7A COMMUNICATION SYSTEM
(SB4000F LINE CARD - ISSUE 6)

1.001 This Addendum supplements Section 518-450-100, Issue 4, July, 1979.

EXHIBIT 1

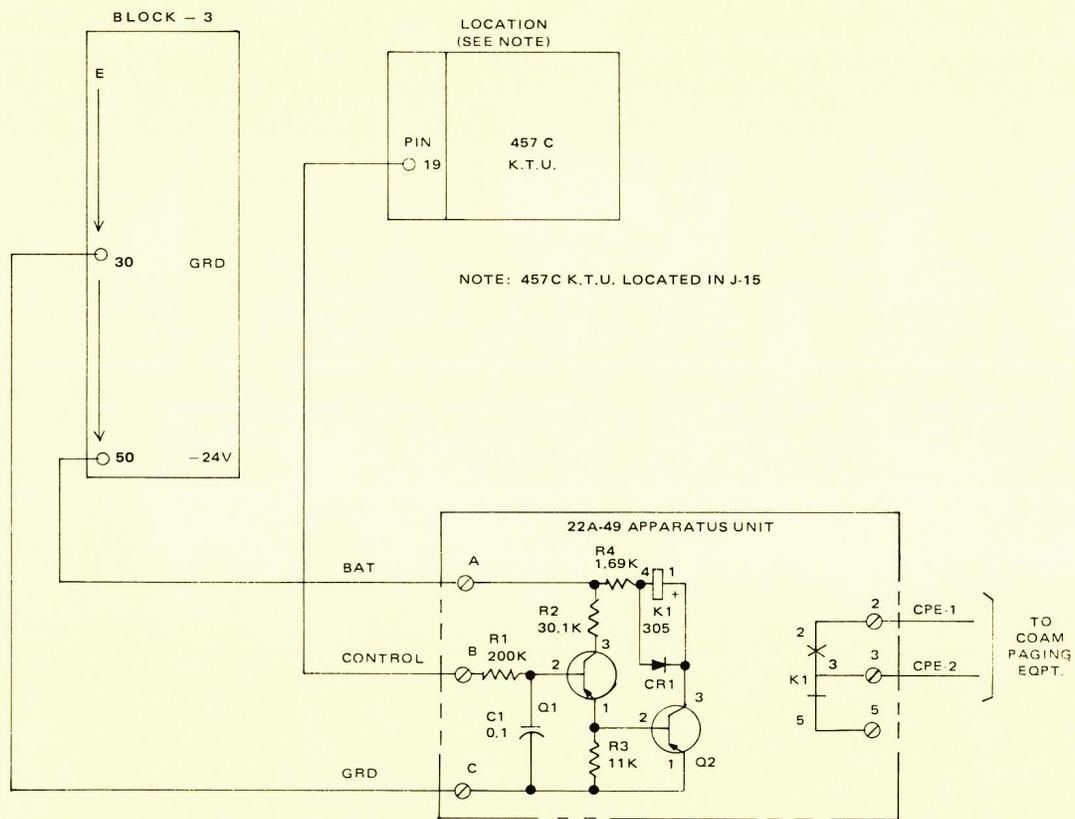
2.001 A 22A-49 apparatus unit is used to Provide contact closure to COAM Paging equipment. (See Exhibit 1 for connecting arrangements)
